REPORT TO THE SUBDIVISION AND DEVELOPMENT APPEAL BOARD

DATE: September 15, 2026	**APPEAL NO.: SDAB2026-0147** **FILE NO.: DP2026-01591**
APPEAL BY: Noelle Leemburg	
FROM A DECISION OF THE DEVELOPMENT AUTHORITY where a **New: Rowhouse Building (1 building), Secondary Suite (5 suites), Accessory Residential Building (Bicycle Storage)** **was approved at 3026 46 Street NW (Formerly: 4648 29 Avenue NW).**	**LAND USE DESIGNATION: R-CG** **Discretionary**
COMMUNITY OF: Montgomery	**DATE OF DECISION: July 21, 2026**
APPLICANT: Ahmed Gouda, Tricor Design Group	**OWNER: Sandeep Suri**

Application Number:	**DP2026-01591**
Application Description:	New: Rowhouse Building (1 building), Secondary Suite (5 suites), Accessory Residential Building (Bicycle Storage)
Land Use District:	Residential - Grade-Oriented Infill
Use Type:	Discretionary
Site Address:	4648 29 AV NW
Community:	MONTGOMERY
Applicant:	TRICOR DESIGN GROUP
Development Applications Review Team	
Planning:	REZA BACCHUS (587) 891-3895 Reza.Bacchus@calgary.ca
Utility Engineering:	BRAD O'KEEFE (403) 966-6846 Brad.O'keefe@calgary.ca
Mobility Engineering:	NABILA HAQUE Nabila.Haque@calgary.ca

Figure 6: TYPICAL GRAVELLED LANES (454.1011.003)

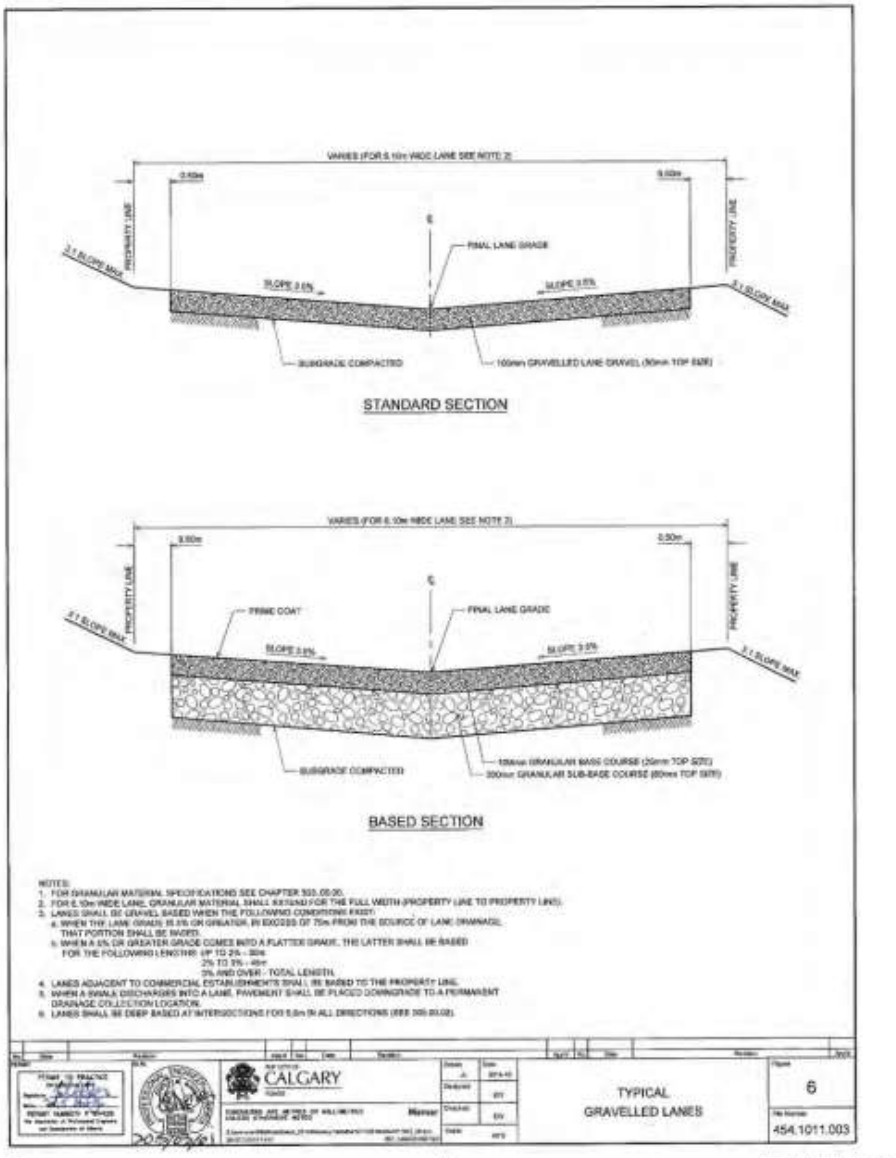
23. Amend the site plans to provide a minimum of 3 cross sections through the full width of the lane at key low points or high points. Full grading information is required to confirm if the lane will drain adequately. Survey information should be provided at a minimum of 5.0m intervals. If drainage issues exist that may result in flooding of the lane or adjacent lots, regrading of the lane may be required. Ensure that the existing lane grades provide positive drainage toward the centre of the lane.

Note: As per the Road Specifications for the gravel lane the cross-fall grade is required to be between 3.5% and 5%. See below image:

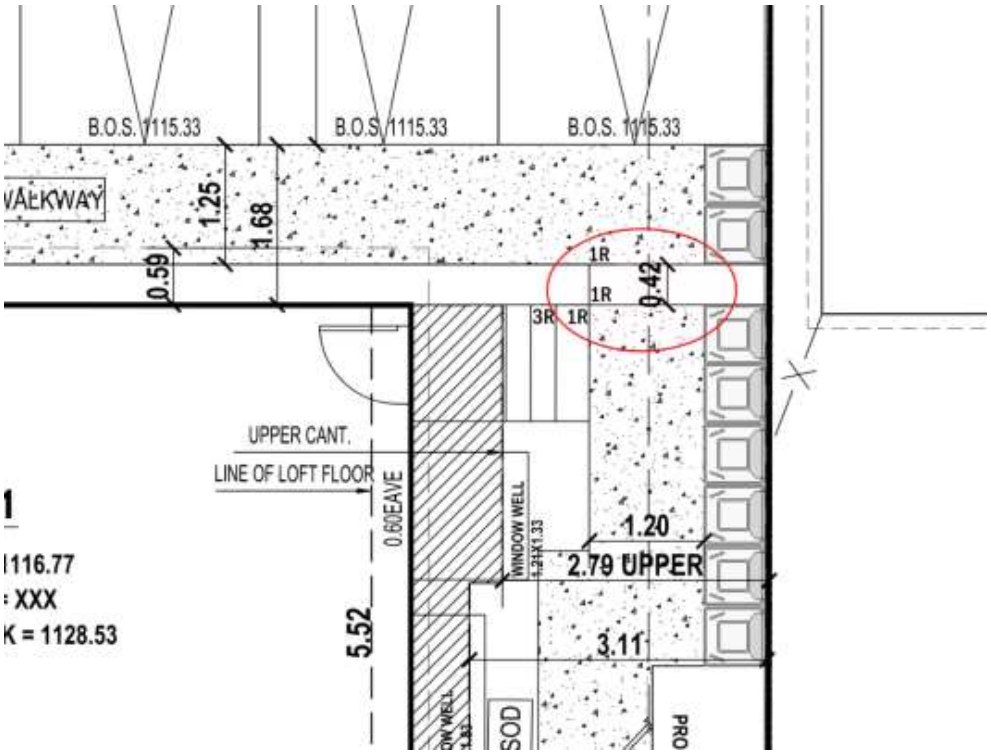
25. Amend the plans to provide a detailed cross-sections for each of the proposed parking stalls. Each section to show existing and proposed dimensions and elevations at the following points: adjacent property line, centerline of the lane, and the front and rear of the parking stalls.

- Ensure that the maximum slope of a motor vehicle parking stall is 4.0% in any direction.

6 **BOULEVARD SECTION - UNIT 5**
SCALE: 1:100

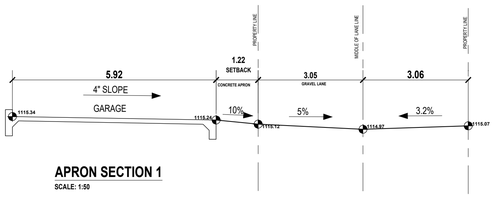
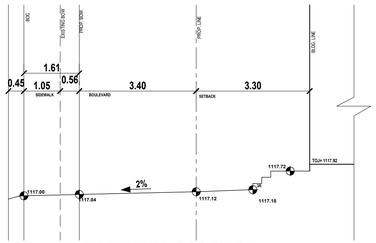
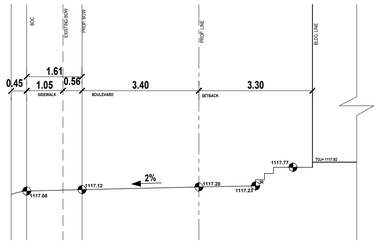
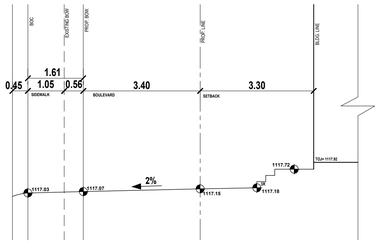
7.	DR2 Update Amend the drawing to ensure boulevards are maintaining 2% slope all through from top of the curb to property line, including through sidewalks, except where constrained by existing conditions (e.g., trees). Currently, Boulevard Sections for Units 1 and 4 indicate sidewalk cross slopes exceeding this requirement. Please also complete and clarify all grading information for Boulevard Section - Unit 5.	**Amended plans to Comply** (Please Refer to Sheet # A-006)

MOVEMENT ROUTES

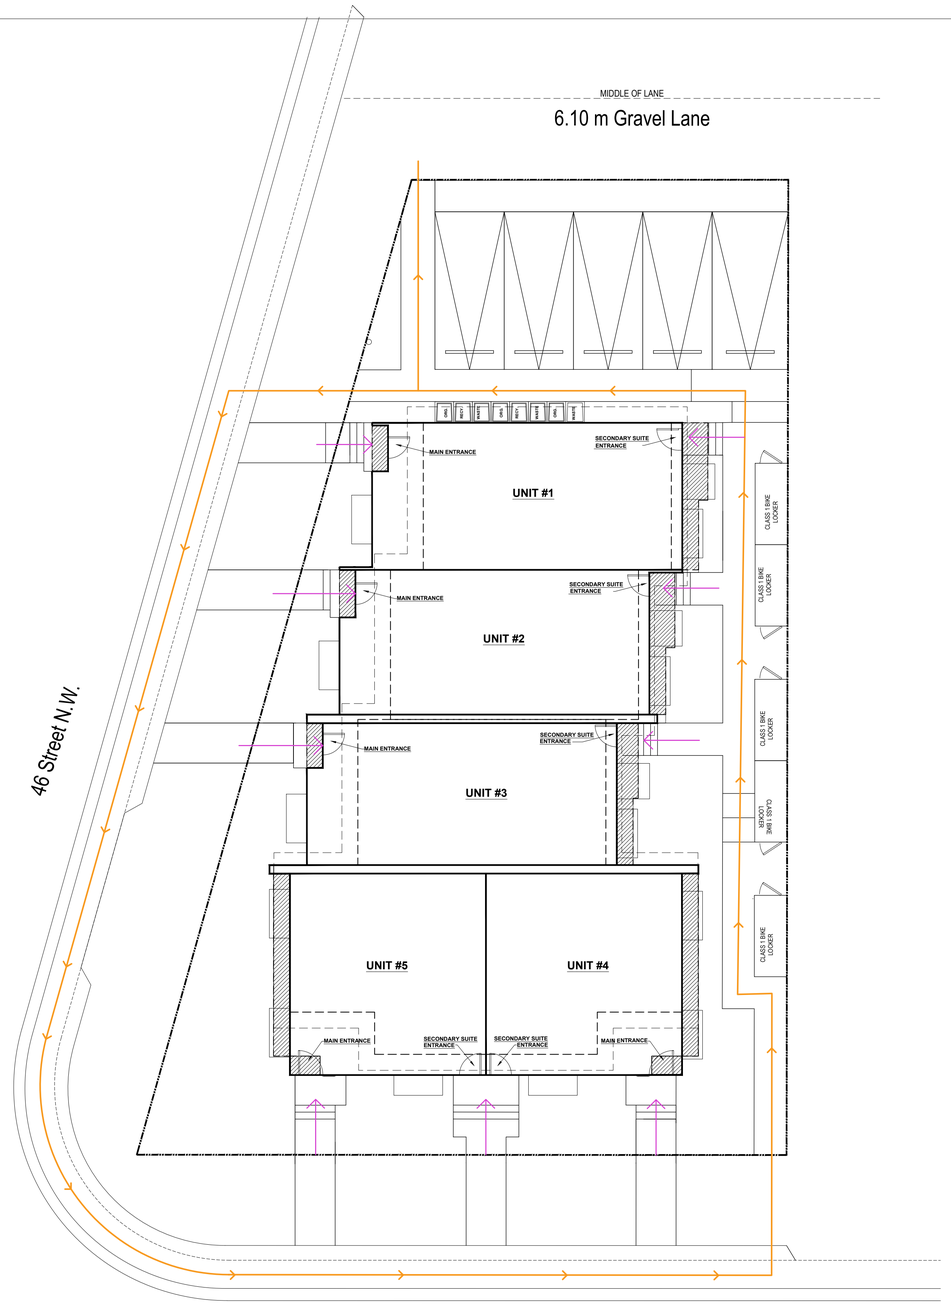
6.	Amend plans to show site navigation routes for how residents will navigate within the site including to and from their units/ suites to the waste collection, bicycle lockers, parking pad, amenity spaces, and public sidewalk. Include details of the door swing radius for proposed garbage screening, mobility storage lockers, and bicycle storage lockers.	**Amended plans to Comply** (Please Refer to Sheet A-011)

DR 2 Update: General
The amended plans (sheet A-011) show a pedestrian route along the western and southern edges of the parcel where there is no walkway. If this is the intended route, amend plans to provide a 1.5m wide walkway to support this.

2.	DR2 Update The amended plans (sheet A-011) show a pedestrian route along the western and southern edges of the parcel where there is no walkway. If this is the intended route, amend plans to provide a 1.5m wide walkway to support this. If this is not the intended route, please revise the route to accurately indicate where residents of the units (along 46 ST NW and 29 Ave NW) will have to walk in order to access the bike lockers, waste bins, and parking stalls. Clearly label all unit and suite entrances and waste bins on this drawing. This is to accurately communicate all relevant navigation information, (e.g., routes, destinations)	**Updated on sheet A-011.** **Amended plans submitted to comply.**

1 PROPOSED LEGAL SUITE FLOOR PLAN
3/16" = 1'-0"

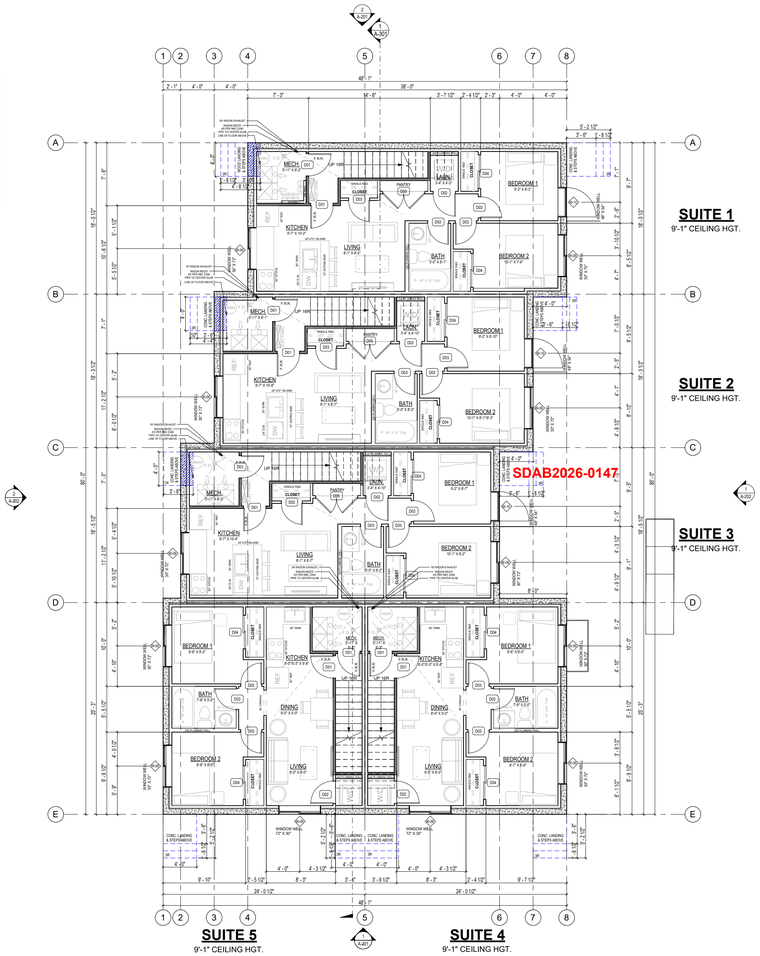
7.	General: Amend plans to correctly label suites on relevant floor plans. Please label suites as "suites" and not "units".	**Amended plans to Comply** (Please Refer to Sheet #A-101)

2 PROPOSED LEFT (NORTH WEST) ELEVATION

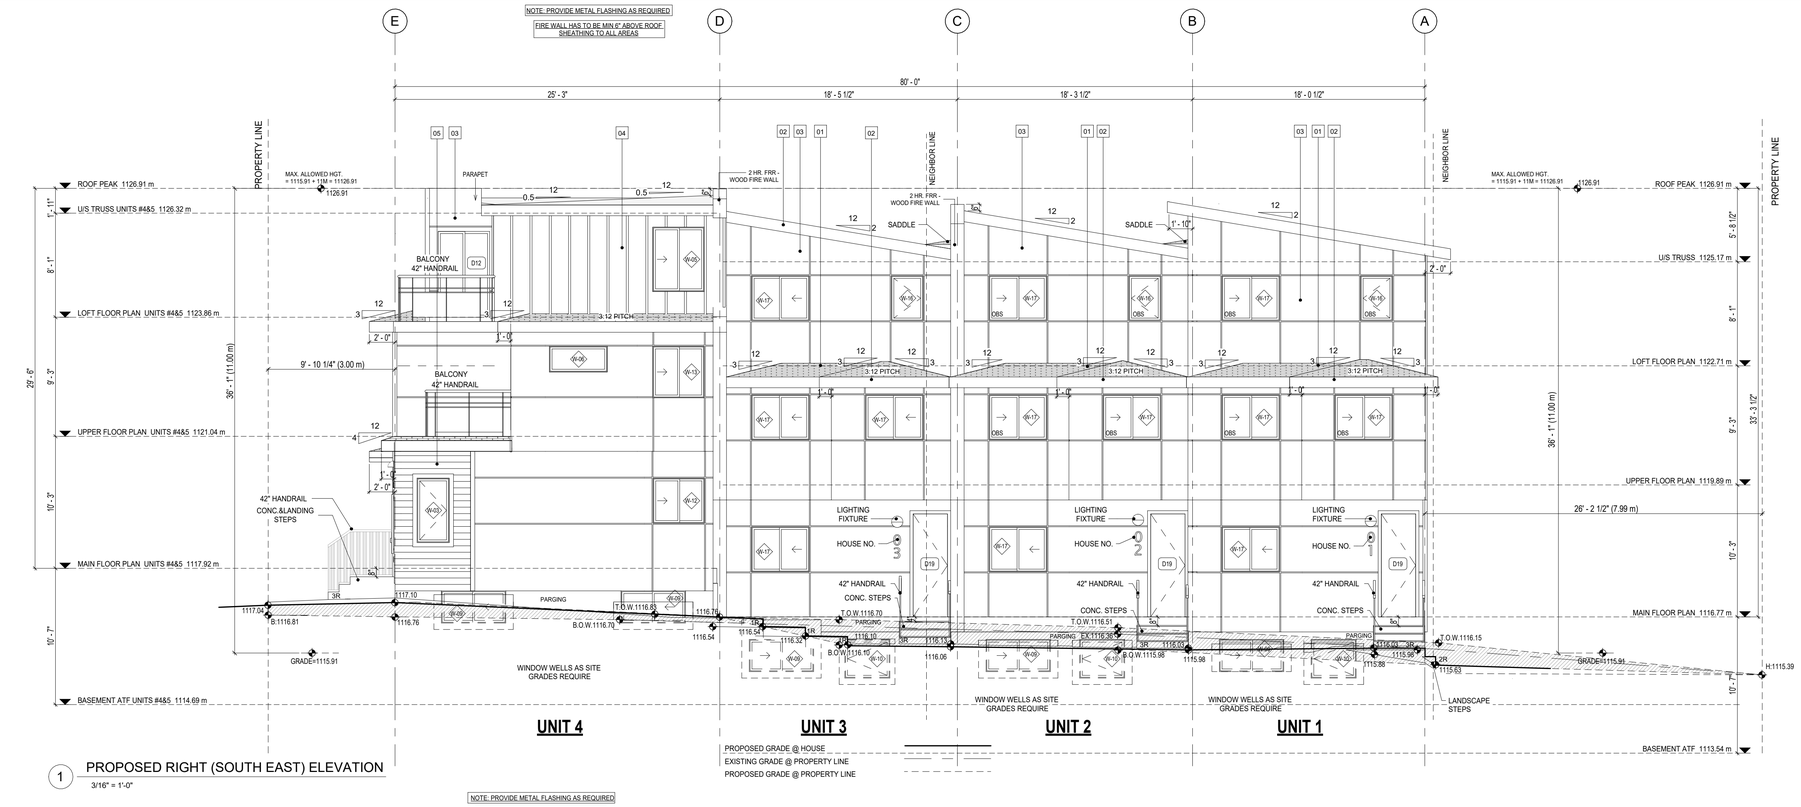
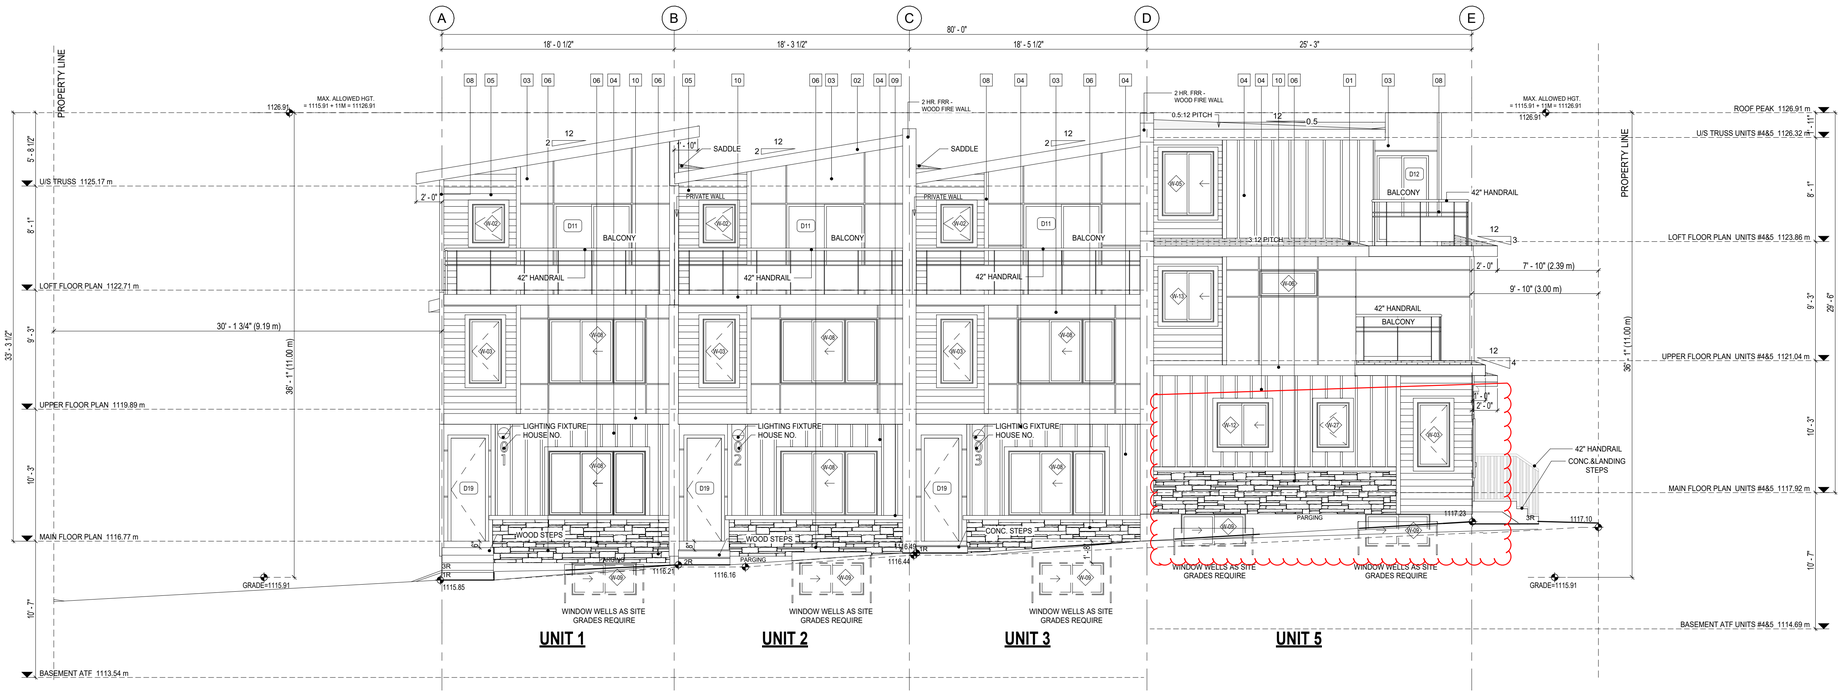
12.	Urban Design - Architecture: Amend plans to architecturally enhance the NW façade of Unit 5, along 46 Street NW, with a more articulated façade and fenestration. Corner units shall address both street-facing facades with elements such as unit entries, window openings, patios, etc. Building side elevations must not interpreted as secondary or of lesser importance.	**Amended plans to Comply** (Please Refer to Sheet #A-201&A-202)
